## ADDENDUM #TWO

**Date:** October 21, 2009  
**Project:** Cumberland Avenue Reconstruction Phase I  
**TSC Job Number:** 5954.002  
**Distribute To:** All Bidders of record, City of West Lafayette, and The Schneider Corporation

**ADD2-C1 (81)**

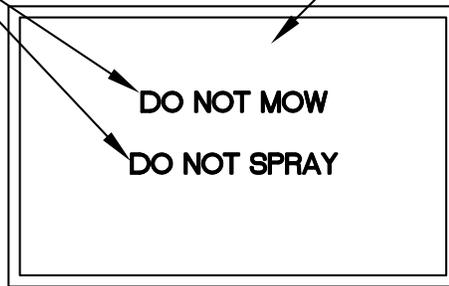
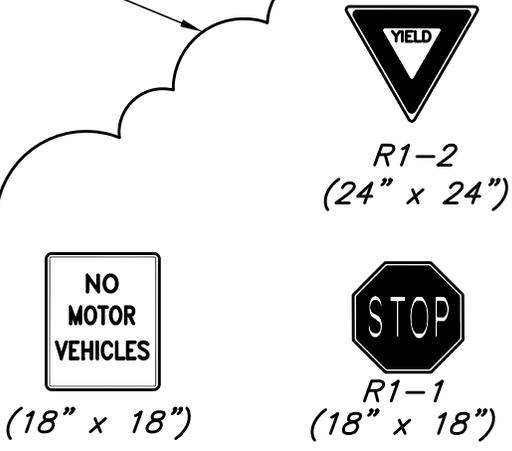
Item	DESCRIPTION
4	<p>Under Alternate #4 there is a pay items for Wetland Plantings Plugs but nowhere is there a list of plant plugs that are required in this area. Also on this item where did the quantity come from as 6900 sft is .158 acre and on sheet 81 of the plans zone 1 &amp; 2 call for .1 acre of plugs each. That is a total of 8712 sft.</p> <p><i>Response: The list of wetland plantings is provided on sheet 87. Sheet 81 has been updated with respect to the legend (refer to drawing ADD2-C1 (81)) to refer to sheet 87 in lieu of sheet 85. The acreage indicated on sheet 81 is approximate as identified by the +/- symbol. The quantity has been revisited by delineating each zone and determined to be 7,610 SFT (square feet). The attached bid form (Section 00300) Item No. 4003 has been adjusted and the excel file reposted on the project ftp site. See attached document for ftp site information.</i></p>

Item	Sheet	DESCRIPTION
1	<b>ADD2-C1 (81)</b>	Refer to attached Drawing ADD2-C1 (81) for updated Legend relative to Contractor Question 4 above. Also, note the addition of the "Native Signage". The bid form (Section 00300) has been update as well.
2	<b>ADD2-C2 (52)</b>	Refer to attached Drawing ADD2-C2 (52) for updated information relative to trail signage and bollards. This is in conjunction with Contractor Question 12. The bid form (Section 00300) has been update as well.
3	<b>ADD2-C3 (52)</b>	Refer to attached Drawing ADD2-C3 (52) for updated information relative to trail bollards. This is in conjunction with Contractor Question 12. The bid form (Section 00300) has been update as well.
4	<b>ADD2-C4 (52)</b>	Refer to attached Drawing ADD2-C4 (52) for updated information relative to trail signage. The bid form (Section 00300) has been update as well.
5	<b>ADD2-C5 (52)</b>	Refer to attached Drawing ADD2-C5 (52) for updated information relative to trail signage and bollards. This is in conjunction with Contractor Question 12. The bid form (Section 00300) has been update as well.

10-21-09 ADDENDUM #2 -ADJUSTED LEGEND SHEET NUMBERS AND ADDED NATIVE SIGNAGE.

**ZONE 1 (ELEVATION 686-687) = ±0.10 Acre PLUGS PLACED 3' O.C.**  
(REFER TO POND LANDSCAPE SPECIFICATIONS, SHEET 87)

**ZONE 2 (ELEVATION 687-688) = ±0.10 Acre PLUGS PLACED 3' O.C.**  
(REFER TO POND LANDSCAPE SPECIFICATIONS, SHEET 87)

(9 SIGNS TO BE PLACED EVERY ±170' IN A LOCATION ADJACENT TO EDGE OF NATIVE PLANTINGS. EXACT LOCATION TO BE APPROVED BY OWNER)

ADD2-C2 (52)

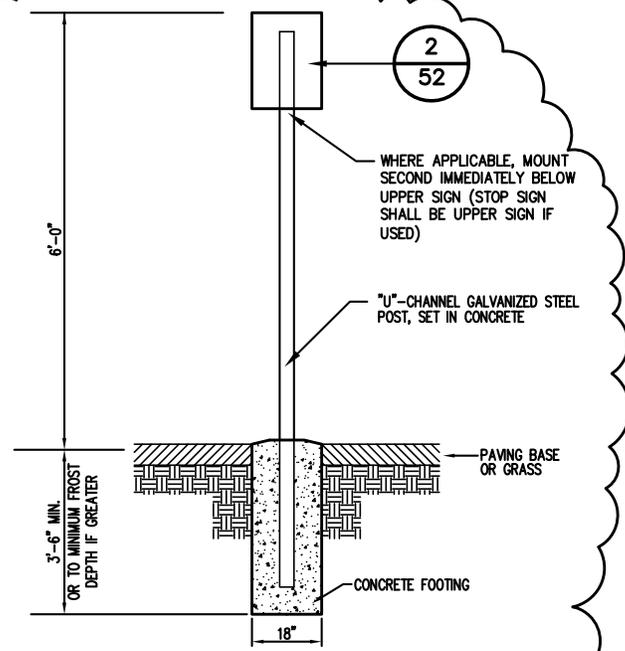
10-21-09 ADDENDUM #2 - TRAIL SIGNAGE AND BOLLARD CLARIFICATIONS.

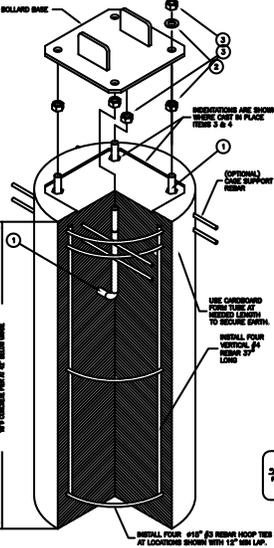
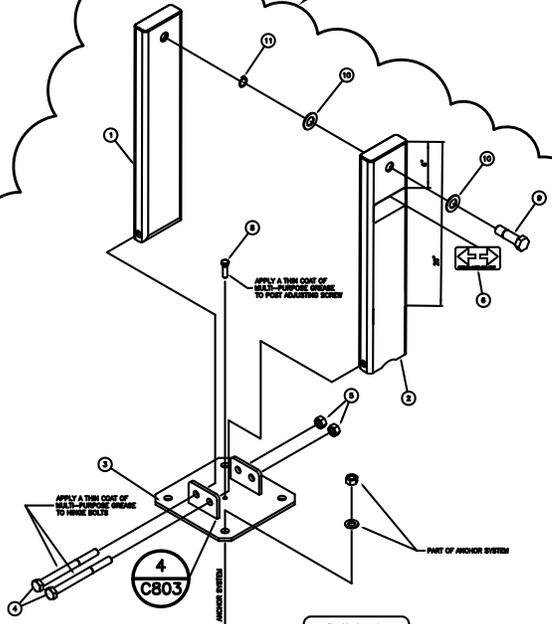
10-21-09 ADDENDUM #2 - TRAIL SIGNAGE AND BOLLARD CLARIFICATIONS.

ADD2-C3 (52)

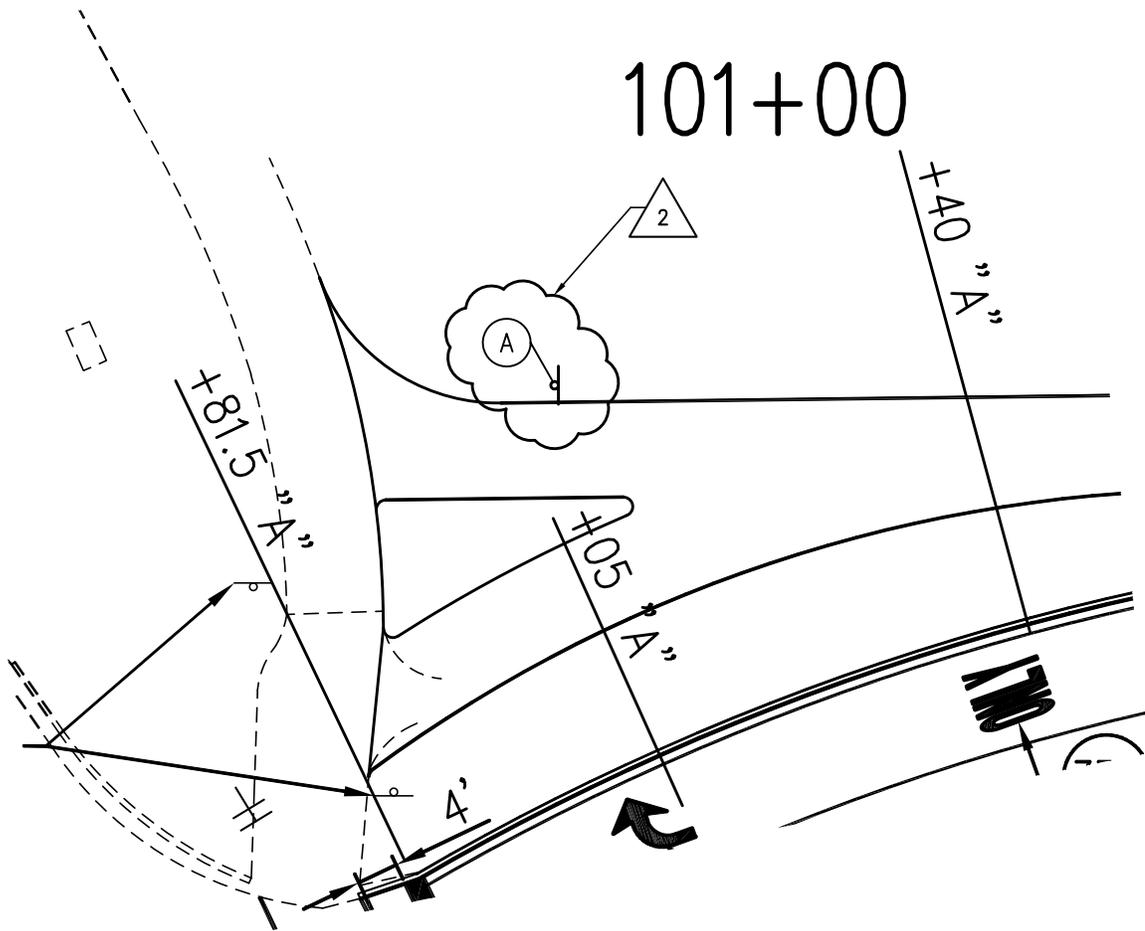
10-21-09 ADDENDUM #2 - TRAIL SIGNAGE AND BOLLARD CLARIFICATIONS.

ADD2-C5 (52)

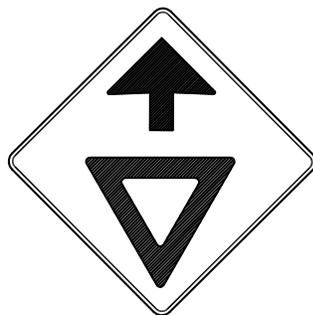
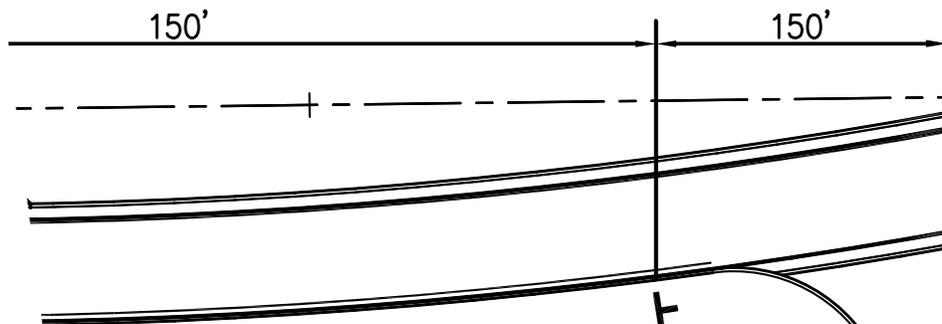
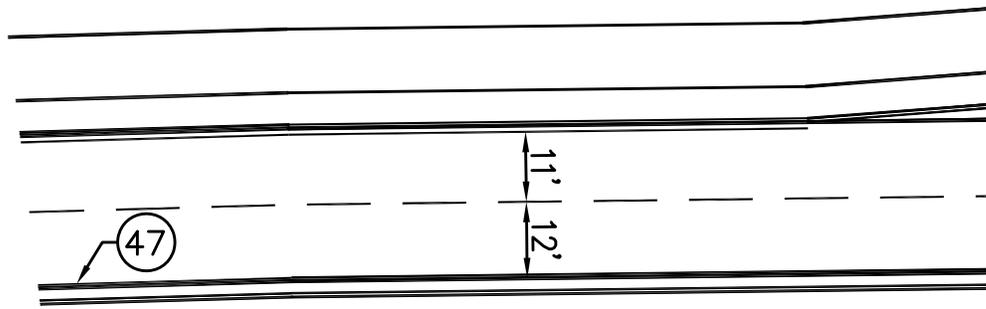
EXISTING BOLLARD TO BE RELOCATED HERE PER DEMOLITION COORDINATION

10-21-09 ADDENDUM #2 - TRAIL SIGNAGE AND BOLLARD CLARIFICATIONS.

ADD2-C6 (53)

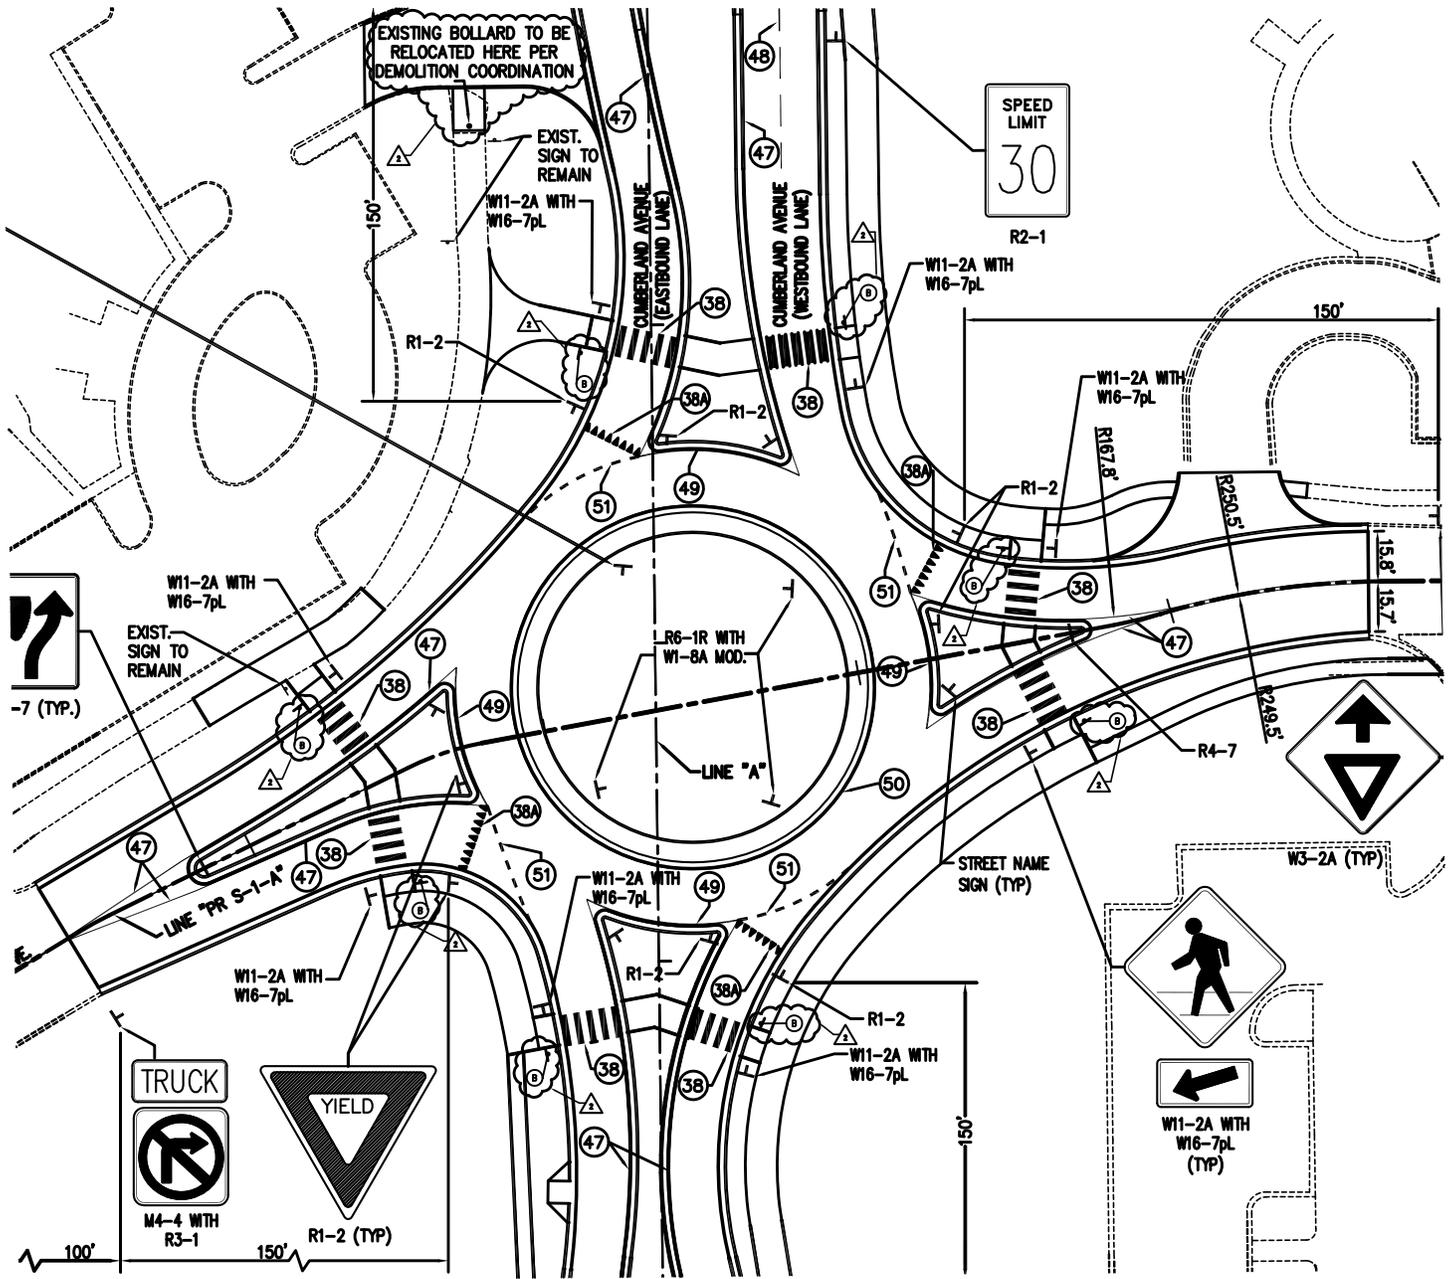
6	<b>ADD2-C6 (53)</b>	Refer to attached Drawing ADD2-C6 (53) for updated information relative to trail signage. The bid form (Section 00300) has been update as well.
7	<b>ADD2-C7 (53)</b>	Refer to attached Drawing ADD2-C7 (53) for updated information relative to trail signage. The bid form (Section 00300) has been update as well.
8	<b>ADD2-C8 (54)</b>	Refer to attached Drawing ADD2-C8 (54) for updated information relative to trail signage and bollards. This is in conjunction with Contractor Question 12. The bid form (Section 00300) has been update as well.

10-21-09 ADDENDUM #2 - TRAIL SIGNAGE AND BOLLARD CLARIFICATIONS.

**ADD2-C7 (53)**

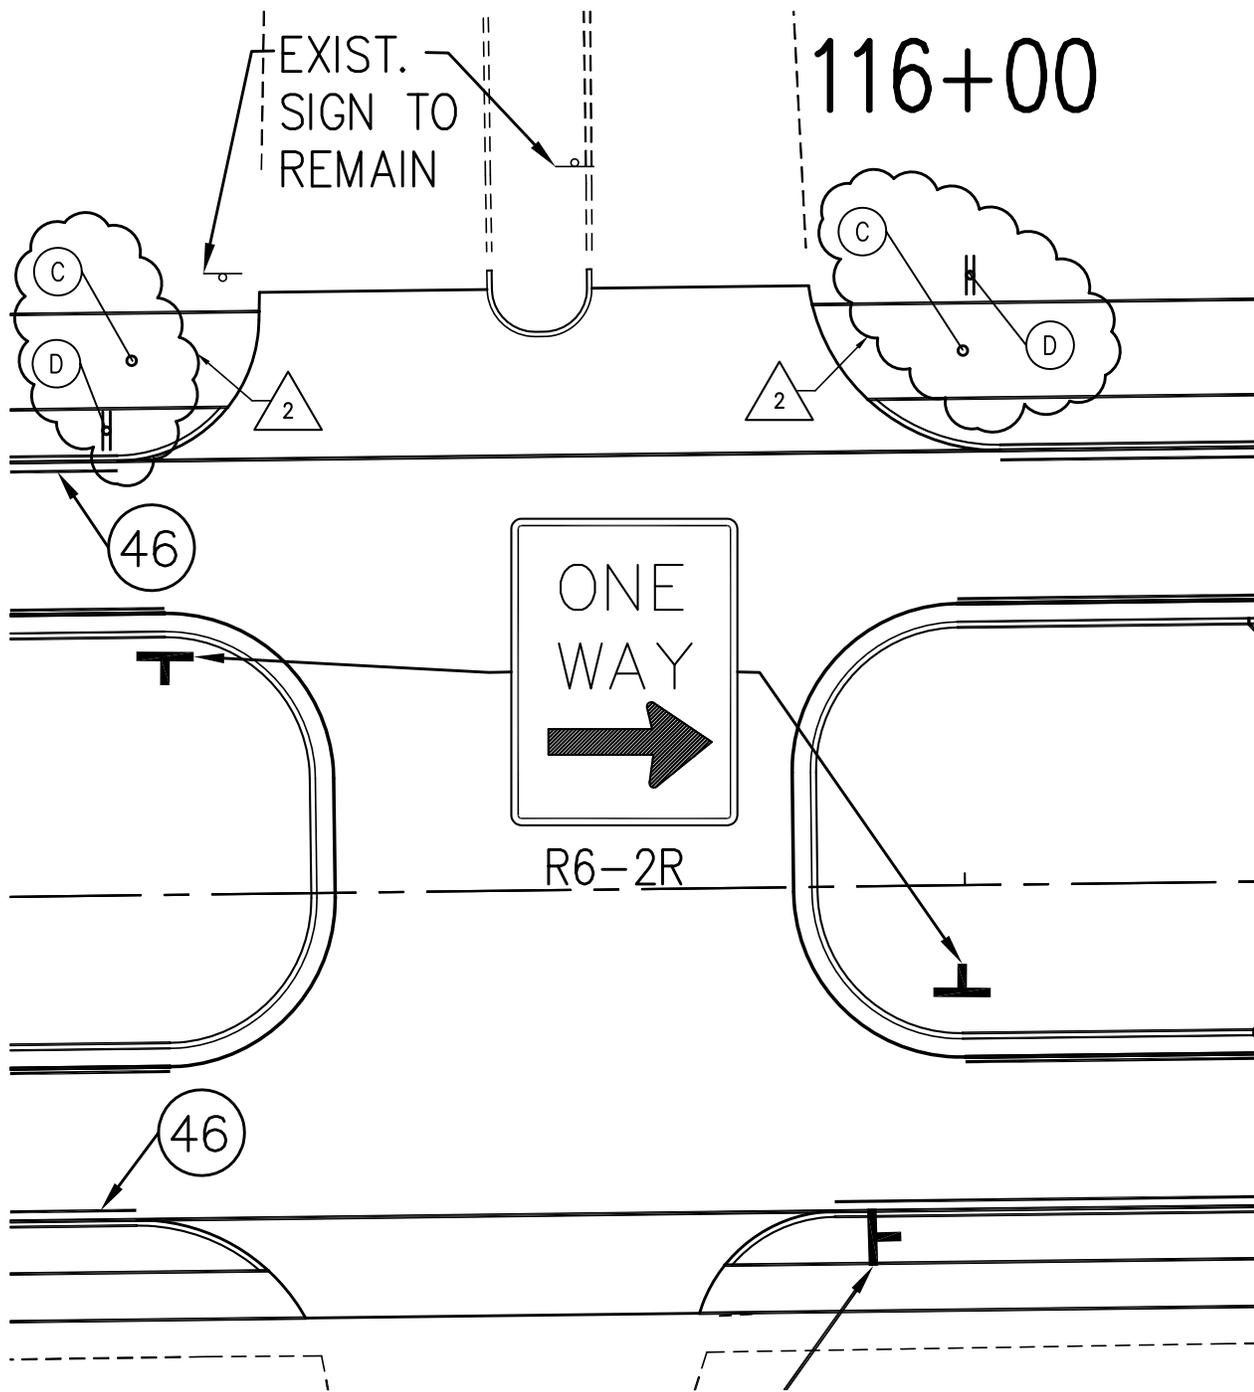
10-21-09 ADDENDUM #2 – TRAIL SIGNAGE AND BOLLARD CLARIFICATIONS.

ADD2-C10(51)

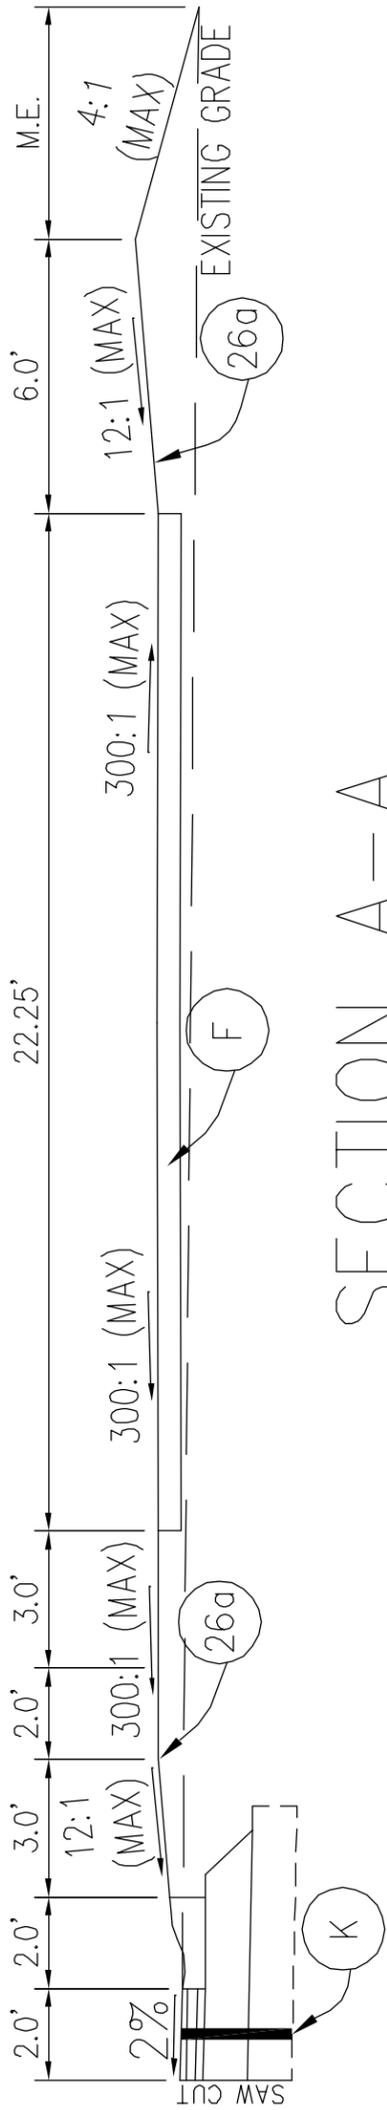
<b>DRAWINGS</b>		
<b>Item</b>	<b>Sheet</b>	<b>DESCRIPTION</b>
9	<b>ADD2-C9 (54)</b>	Refer to attached Drawing ADD2-C9 (54) for updated information relative to trail signage and bollards. This is in conjunction with Contractor Question 12. The bid form (Section 00300) has been update as well.
10	<b>ADD2-C10 (51)</b>	Refer to attached Drawing ADD2-C10 (51) for modification to Alternate #3.
11	<b>ADD2-C11 (51)</b>	Refer to attached Drawing ADD2-C11 (51) for modification to Alternate #3.
12	<b>ADD2-C12 (50)</b>	Refer to attached Drawing ADD2-C12 (50) for modification to Alternate #3.

2 REV 10-21-09 PEDESTRIAN ISLAND DESIGN CHANGE.

INLET TYPE D-6  
AND 50' OF TYPE 2  
PIPE BLIND TIE INTO  
EXISTING CROSS PIPE

PIPE INV. ELEV = MATCH EXISTING  
NOTE: IF PIPE SLOPE IS LESS THAN  
0.3% THE CONTRACTOR SHALL  
CONSULT THE ENGINEER.

ADD2-C11(51)

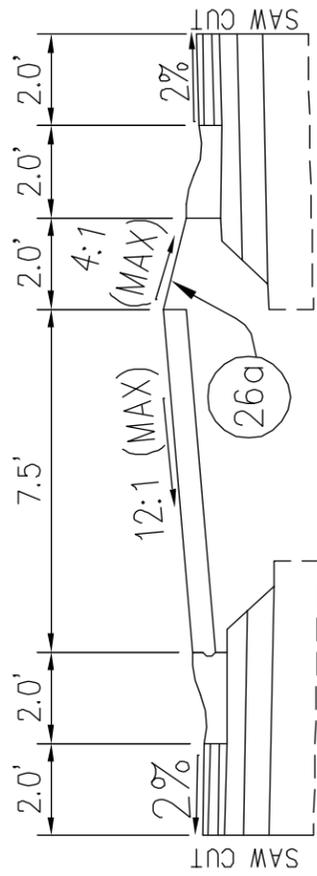
2 REV 10-21-09 PEDESTRIAN ISLAND DESIGN CHANGE.

ADD2-C12(50)

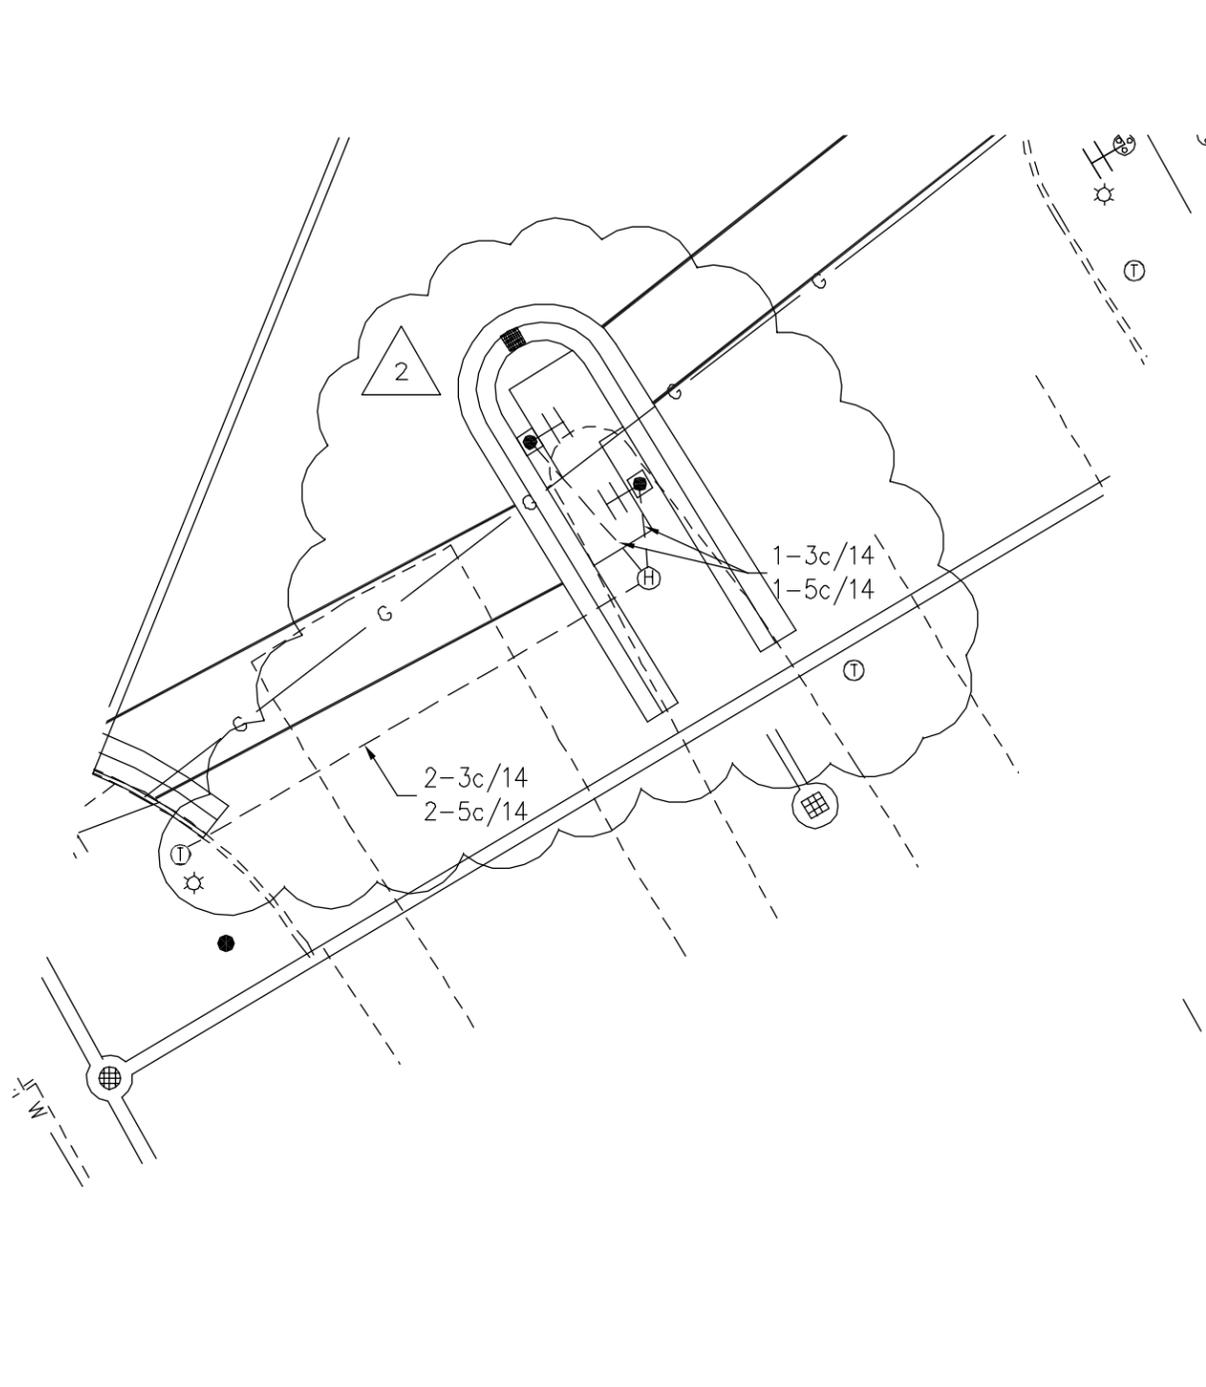
CONTRACTOR QUESTIONS	
Item	DESCRIPTION
10	<p>On sheet 51, in the concrete island, what is the symbol (H) for?</p> <p><i>Response: H is a symbol for signal hand hole. Drawing ADD2-C12 (50) is included with this addendum.</i></p>
11	<p>On sheet 51, it looks like the quantities for the ramp (G) &amp; road patch are in the base bid, is that correct or is it in Alternate #3? If it's in the base bid, will you still be doing that ramp if Alternate #3 is not accepted?</p> <p><i>Response: Ramp G should be in alternate bid #3. HMA for patching has been changed to HMA for widening and is in alternate bid #3 only. Ramp G pay item was moved to Alternate #3. Ramp G is not necessary if Alternate #3 is not selected and has been removed from the bid form Item No. 32 and moved to Item No. 3025. Bid form relative to Alternate #3 has been modified based on this response.</i></p>
12	<p>Is there a detail or spec for the bollards?</p> <p><i>Response: Item No. 28 bollards shown on sheet 54 additional information has been provided with this addendum. Refer to drawings ADD2-C2 (52), ADD2-C8 (54) and ADD2-C9 (54) and below for additional information and details. The bid form (Section 00300) has been updated to reflect the quantity 2 EA (each). Item No. 96 has been inserted to account for the two bollards to be reused.</i></p>

REV 10-21-09 PEDESTRIAN ISLAND DESIGN CHANGE.
